APPENDIX 6

Comments and Responses on Proposed 2016 Monitoring Network Plan, Revision 0

COMMENTS AND RESPONSES ON
PROPOSED 2016 MONITORING NETWORK PLAN, REVISION 0

The public comment period for the proposed 2016 Missouri Monitoring Network Plan opened on May 27, 2016 and closed on June 28, 2016. The Missouri Department of Natural Resources' Air Pollution Control Program prepared the 2016 Monitoring Network Plan to address the requirements of 40 CFR 58.10 (a) (1) for annual submittal of a plan to provide information on current State or Local Air Monitoring Stations (SLAMS), other ambient air monitoring, and any proposed network changes for the upcoming year.

Figure 12. Top 300 receptors per DNR's original modeling.

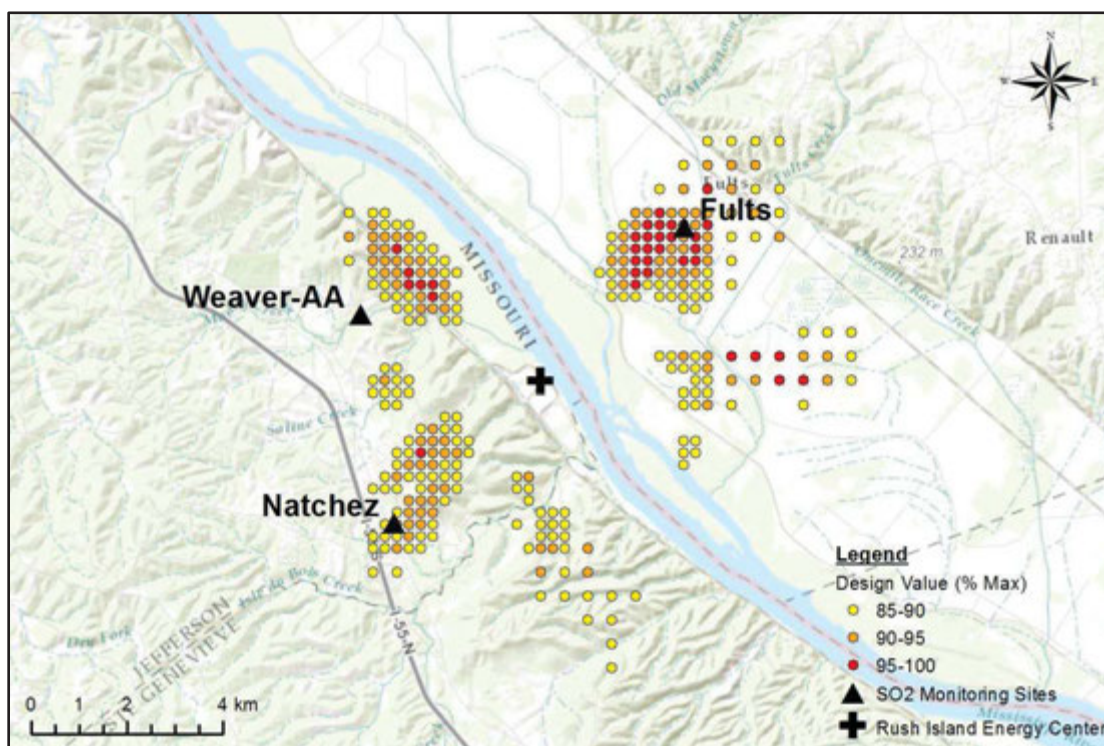
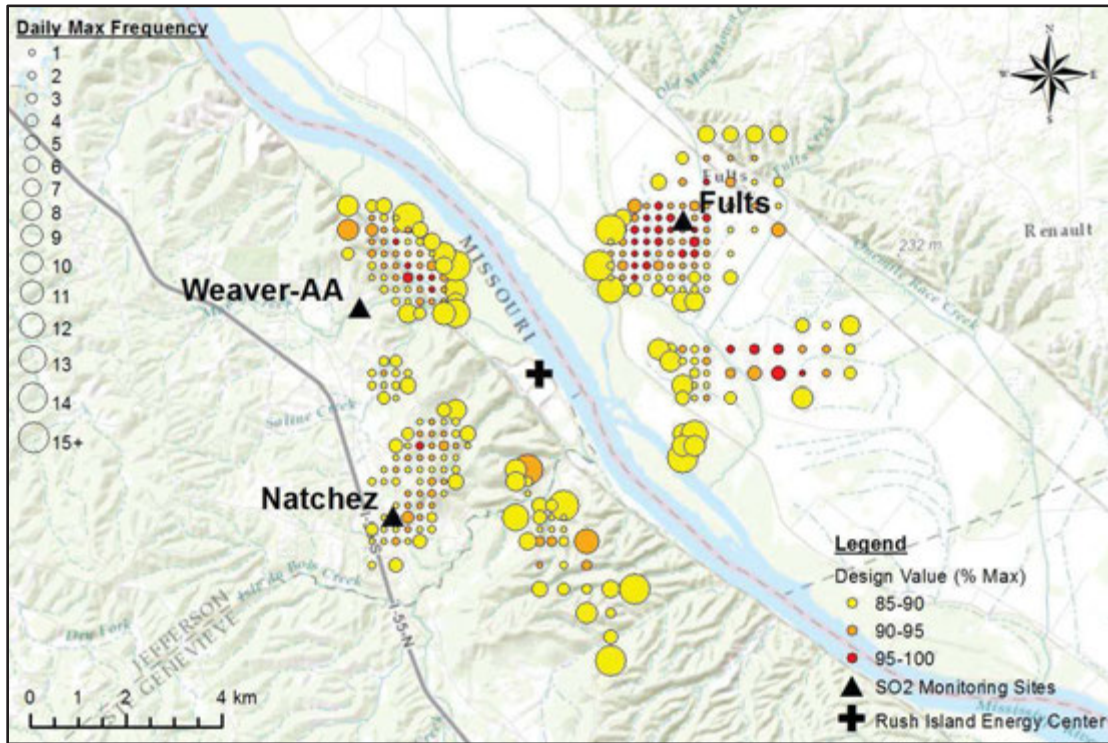
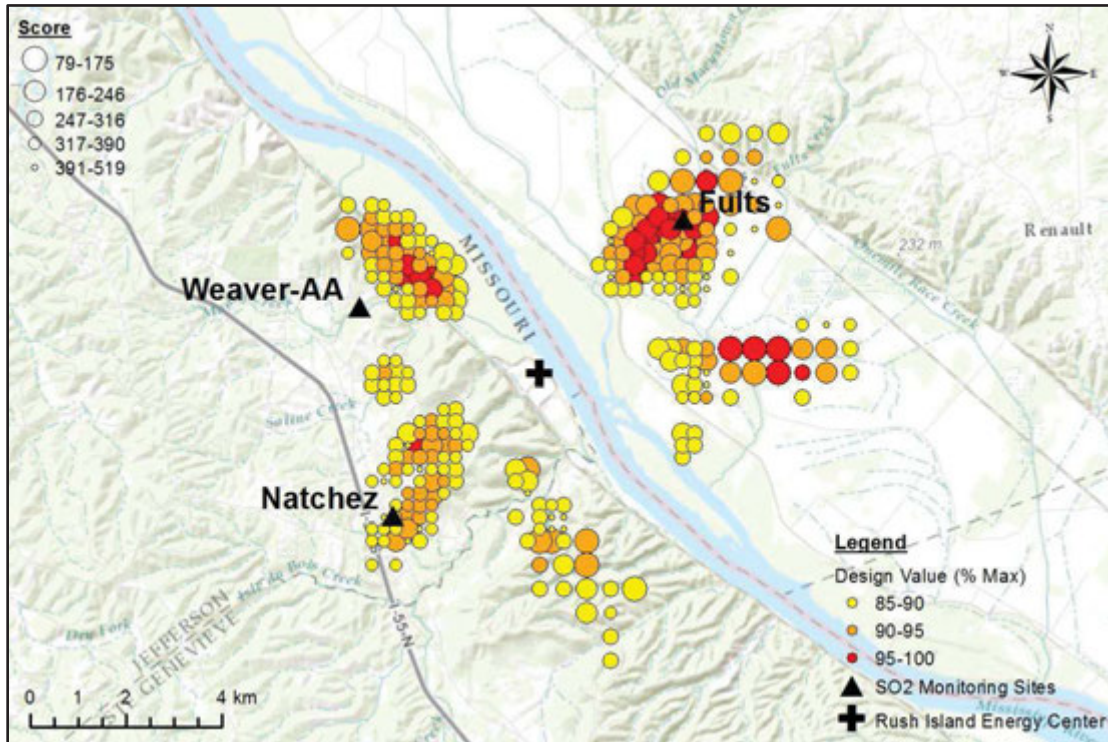
More importantly, although DNR generally followed the strategy in its supplemental analysis of the Rush Island SO₂ monitoring sites,¹⁹ it omitted the most crucial, final step – ranking receptors according to their score (the sum of concentration rank and day rank). As a result, it ignored the entire purpose of conducting the TAD-suggested prioritization analysis, and its supplemental analysis offers no support for the location of the Rush Island monitors. First, DNR reviewed the modeling performed for its original analysis and identified the 300 receptors with the highest modeled design values. These receptors are shown in Figure 12. Next, it reran its model for the top 300 receptors using the MAXDAILY output option in AERMOD to determine the maximum 1-hour concentration for each receptor for each day and then tallied the number of days each receptor had the highest 1-hour daily maximum concentration among all receptors. The frequency of having the highest 1-hour daily maximum concentration among the top 300 receptors is shown in Figure 13. Finally, it ranked the top 300 receptors by both design value (concentration rank) and the number of days each had the highest 1-hour daily maximum concentration (day rank) and calculated a score for each one by adding its concentration rank and its day rank. These scores are shown in Figure 14.

Figure 16. Comparison of polygons used in DNR's original and supplemental analyses.

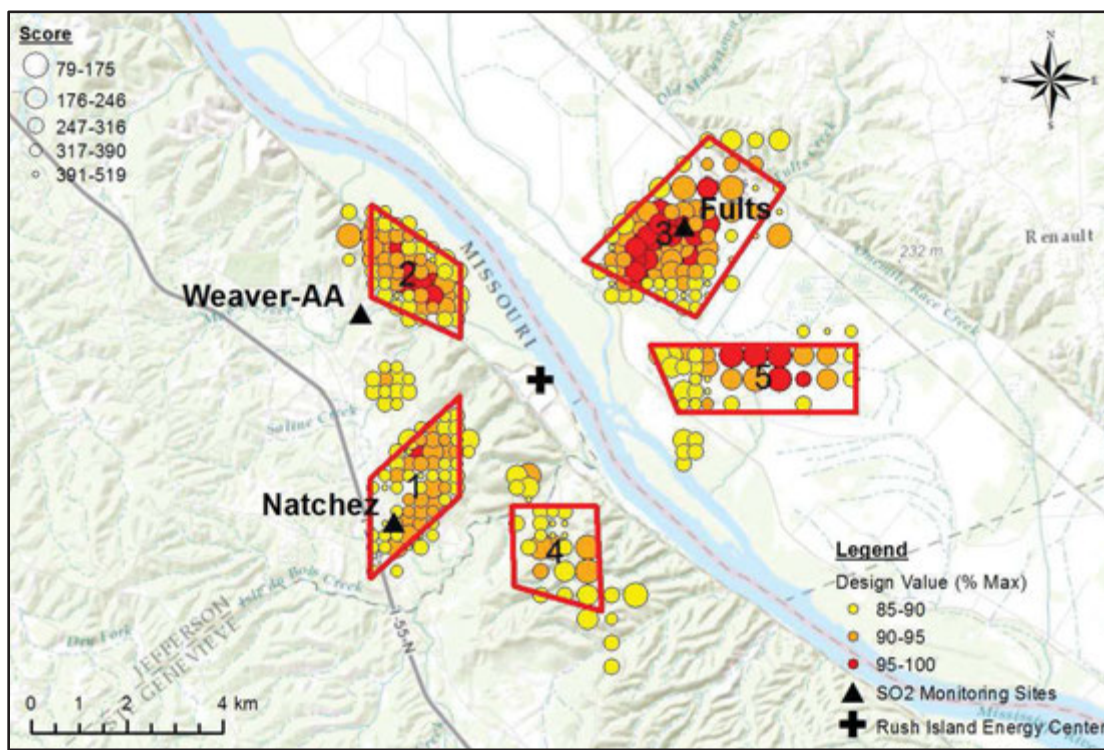
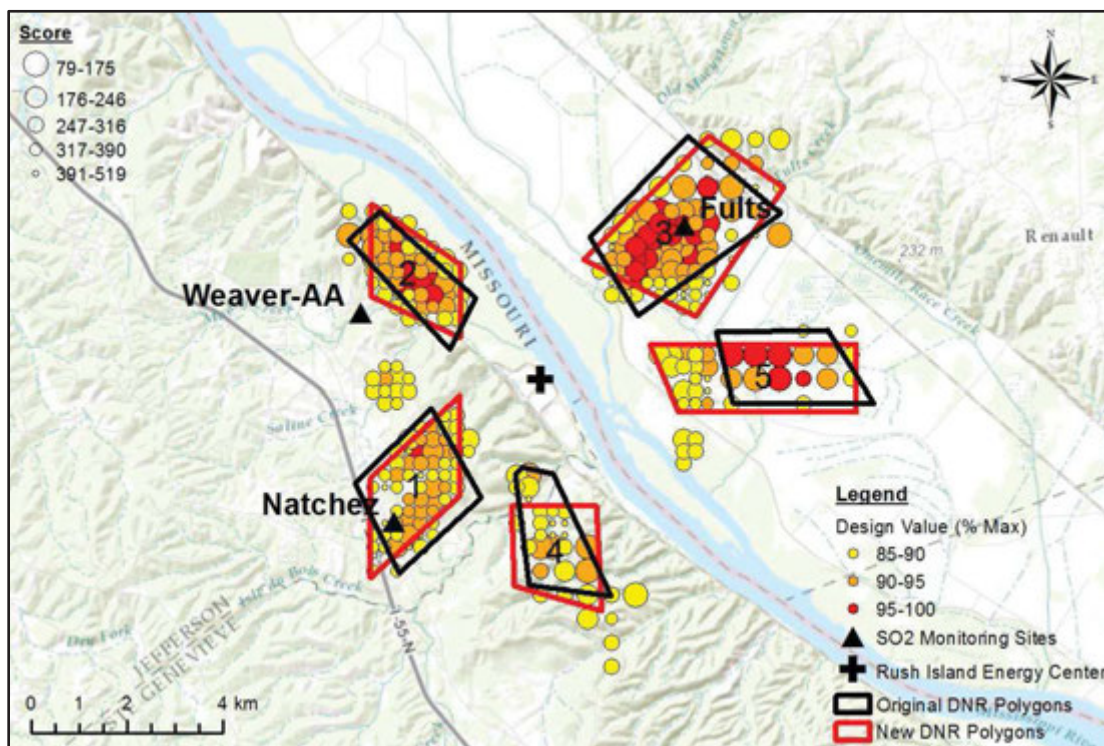
At this point, however, DNR abandoned the scoring strategy described in the Monitoring TAD. Instead of performing the final step and ranking receptors by their scores in order to provide a list of locations ranked in general order of desirability with regard to permanent monitor siting, it reverted to the flawed methodology used in its original analysis and counted the number of top receptors within five numbered polygons arrayed around the plant. These polygons are shown in Figure 15. It then ranked the polygons by the number of top receptors within each one and concluded, based on the fact that polygons 1, 2, and 3, where DNR Figures S-2 and S-3 show the monitors are located, contain the most top receptors, that the supplemental analysis supports its earlier conclusion that the siting of the monitors is reasonable.

- 2) The polygons used in DNR's supplemental analysis are a different size and shape than the ones used in its original analysis. This is shown in Figure 16. Setting aside the bias inherent in DNR's methodology owing to its use of a telescoping receptor grid, the supplemental analysis should use the same polygons as the original analysis if polygon rankings based on receptor counts are going to be compared.

Figure 17. Receptors with the 10, 25, 50, and 100 highest score ranks (clockwise from upper left). Peak concentration areas (design value $>90 \text{ ug/m}^3$) are shaded red.

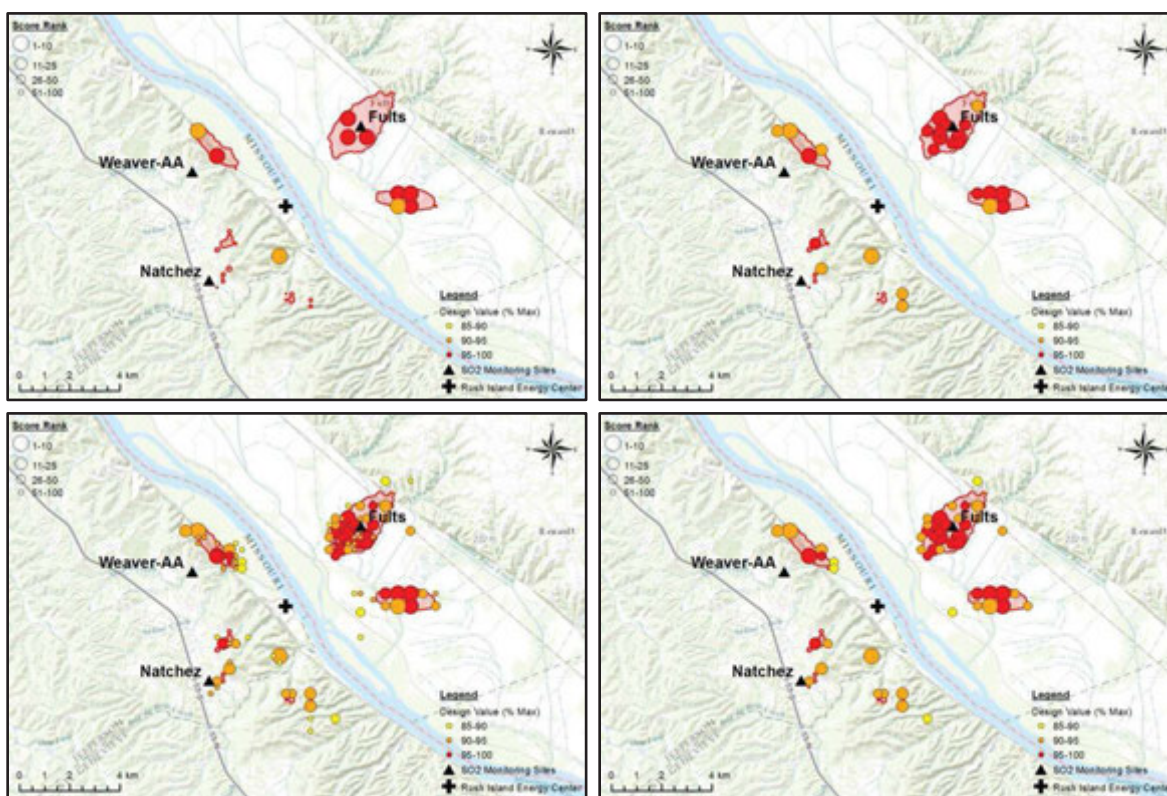
Had DNR followed the scoring strategy described in the TAD through to the end, and ranked receptors by their scores to come up with a list of locations ranked in general order of desirability with regard to monitor siting, its supplemental analysis would have reached a different conclusion regarding the siting of the Rush Island monitors. Figure 17 shows the 10, 25, 50, and 100 receptors with the highest score ranks superimposed on the peak concentration areas (design value $>90 \text{ ug/m}^3$). The 10 receptors with the highest score ranks would be the most desirable monitor locations, and all but one are clustered in the three largest peak concentration areas, which are where the Rush Island SO_2 monitors should have been sited. The fact that almost all of the 10 highest ranked receptors – taking into account modeled design values *and* frequency of having the highest 1-hour daily maximum concentration – are located in these areas only reinforces that point. Similar results are obtained by looking further down the priority list at the 25, 50, and 100 highest ranked receptors, the vast majority of which are located in the same three peak concentration areas.

Only one of the three Rush Island monitors is sited in these peak concentration areas. The Fults monitor is sited in the large peak concentration area located northeast of the plant, which contains three of the 10 highest ranked receptors and upwards of half of the 100 highest ranked receptors. The Natchez and Weaver-AA monitors, however, are located outside of the large peak concentration areas east and northwest of the plant, which collectively contain six of the 10 highest ranked receptors about 25 of the 100 highest ranked receptors. DNR should require Ameren to relocate the Natchez and Weaver-AA monitors to these areas, as they clearly represent – along with the area where the Fults monitor is located – the areas where peak concentrations are expected to occur based on DNR’s own modeling and the receptor scoring strategy described in the TAD.

Figure 18. Top 300 receptors based on 2013-2015 data.

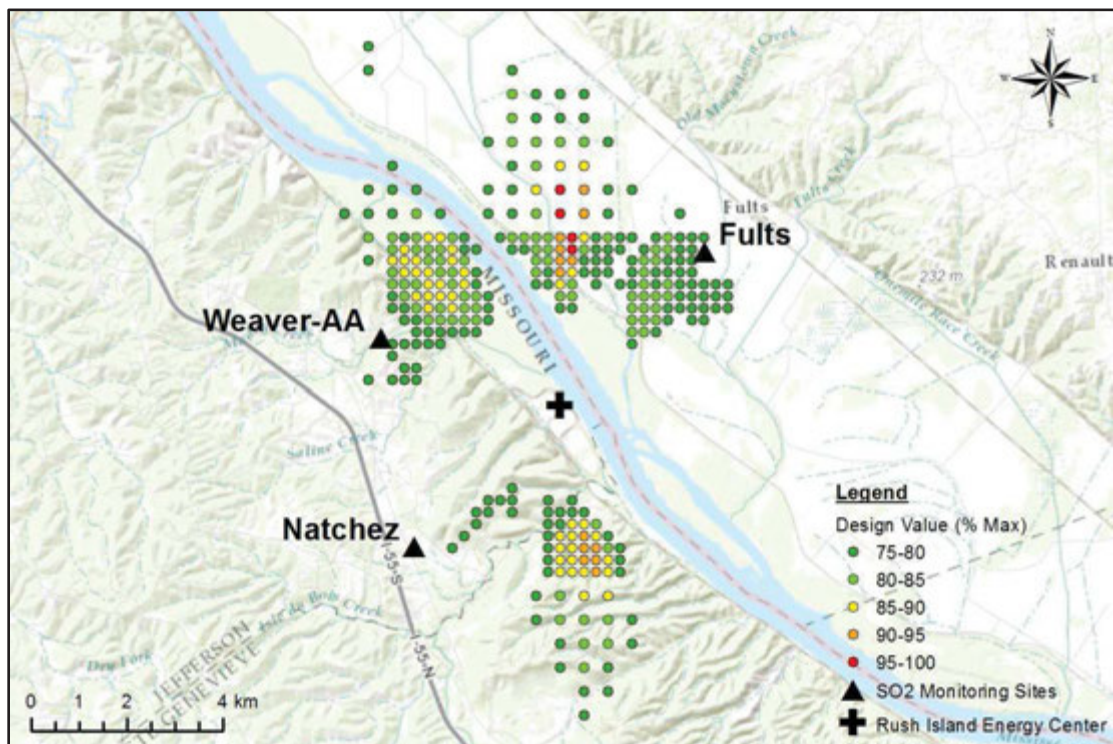
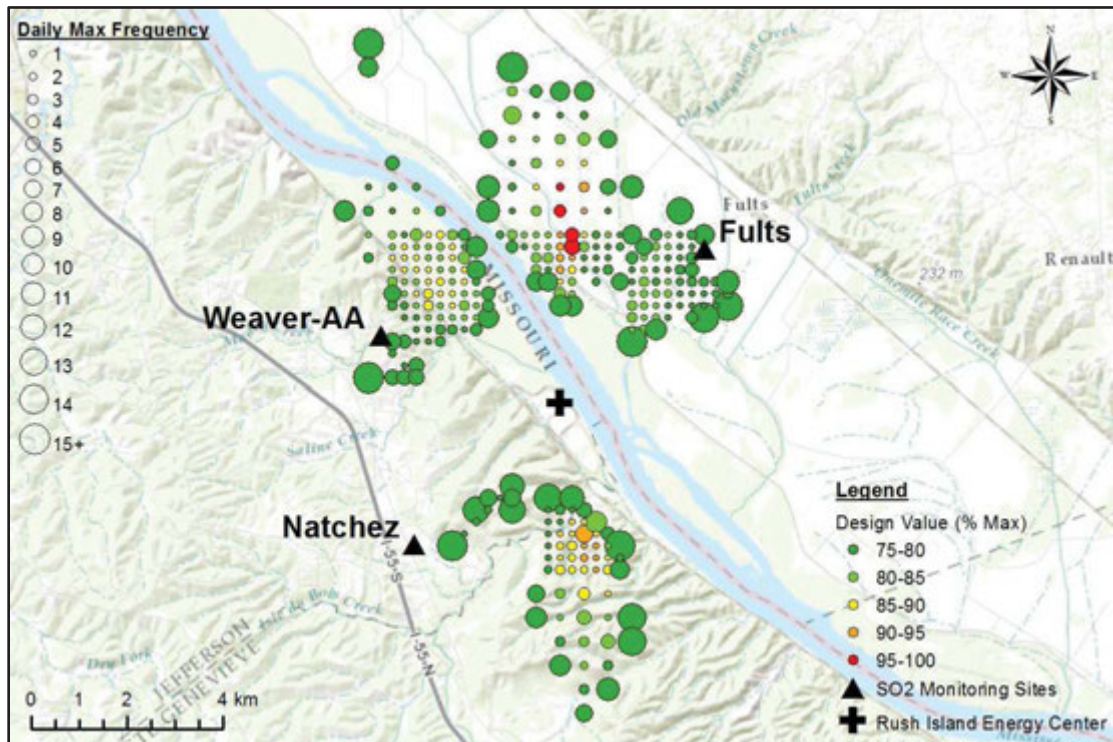
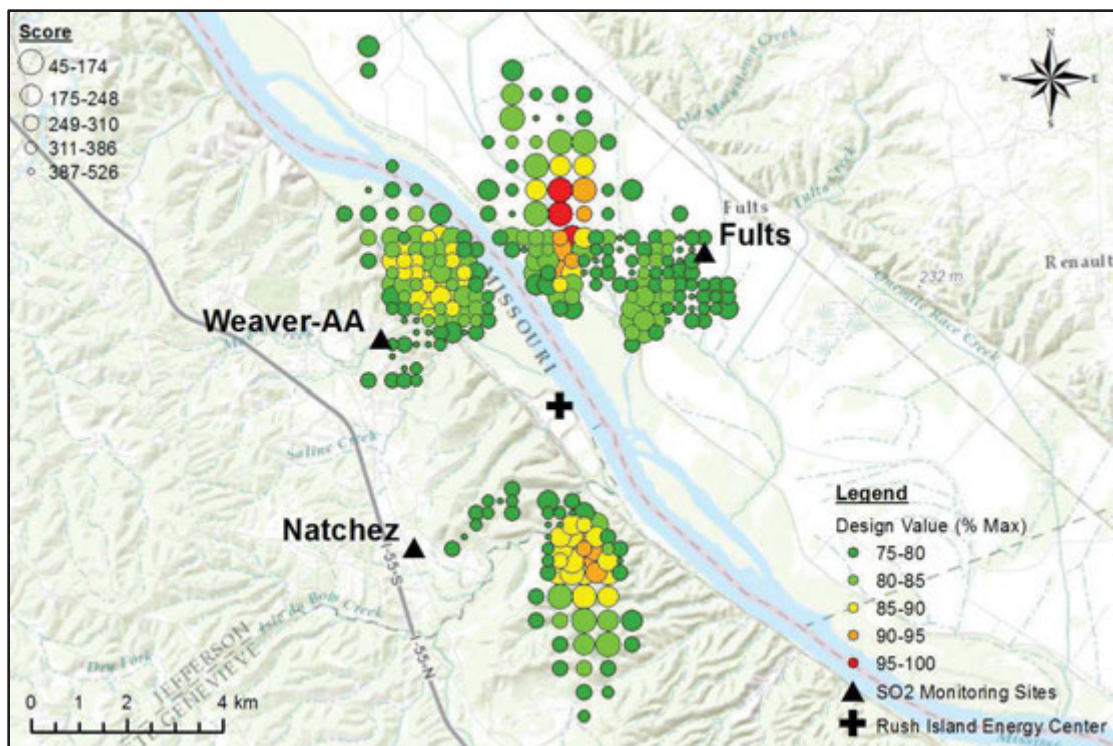
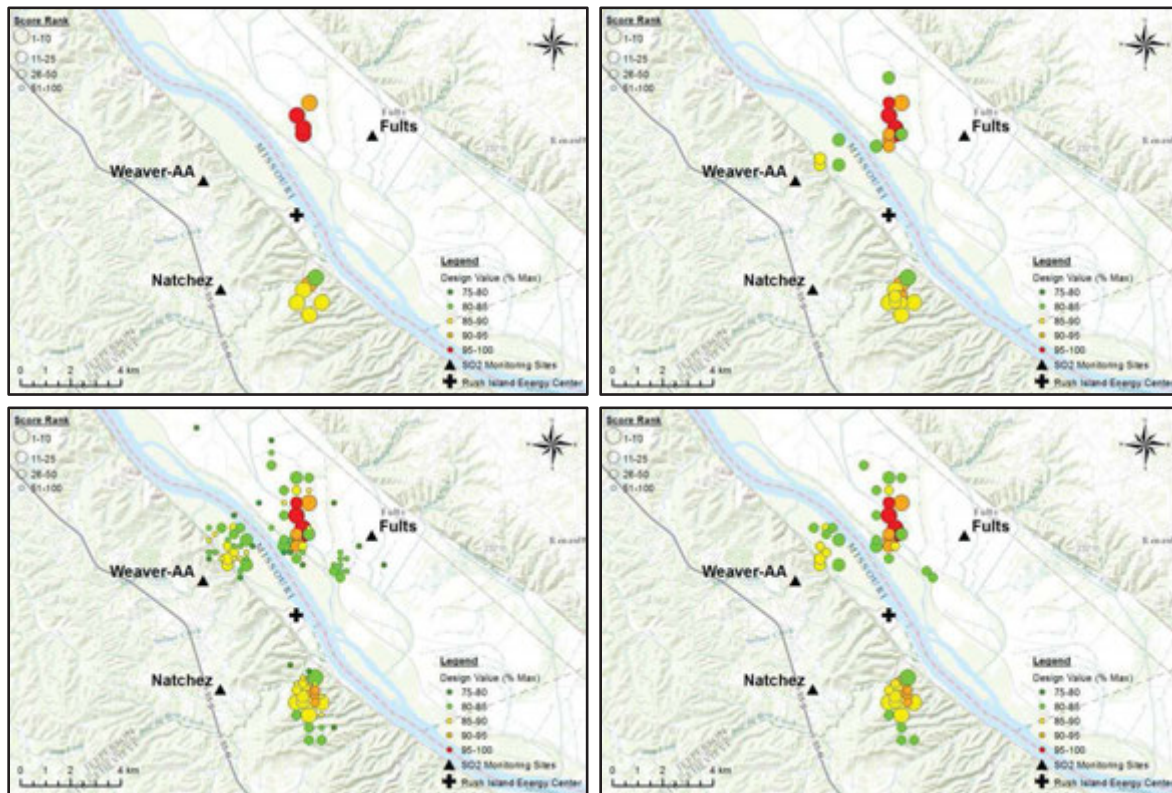
Updating DNR’s modeling to use 2013-2015 emissions and meteorological data results in markedly different results from those obtained using 2011-2013 data. Figure 18 shows the 300 receptors with the highest modeled design values when 2013-2015 data are used; Figure 19 shows the frequency of having the highest 1-hour daily maximum concentration among these receptors; and Figure 20 shows their scores, which were calculated by adding their respective concentration ranks and day ranks per the scoring strategy described in the TAD.

When 2013-2015 data are used, the highest concentration areas shift and are located immediately north and south of the plant instead of to the east, northeast, and northwest, as shown in Figure 18. The receptors with the lowest scores – i.e., those with the highest combined concentration rank (based on modeled design value) and day rank (based on frequency of having the highest 1-hour daily maximum concentration) – are similarly located north and south of the plant, as shown in Figure 20. Furthermore, when the top receptors are ranked by score so as to provide a list ranked in general order of desirability with regard to siting monitors in accordance with the Monitoring TAD, there are no high-ranking receptors near any of the existing monitors. Figure 21 shows the 10, 25, 50, and 100 receptors with the highest score ranks based on modeling using 2013-2015 data.

The significant difference in modeled peak concentration areas when 2013-2015 data are used in lieu of 2011-2013 data demonstrates one of the major drawbacks (besides providing data at only a limited number of discrete points) of using monitoring as a means of determining NAAQS compliance. As emissions and meteorological conditions change over time, peak concentration areas can shift, leaving monitors that may have been properly sited at one time in areas that are no longer appropriate. For example, the Fults monitor is appropriately sited based on modeling using 2011-2013 data but is not in a peak concentration area at all – let alone at a high priority location based on the scoring strategy described in the TAD – based on modeling using 2013-2015 data. This points to the need for additional monitors at Rush Island to ensure that the network is capable of adequately characterizing peak concentrations around the plant, which could easily shift again in the future. In addition to requiring relocation of the Natchez and Weaver-AA monitors to peak concentration areas as discussed above, DNR should require the addition of monitors immediately north and south of the plant, in peak concentration areas based on modeling using 2013-2015 data.
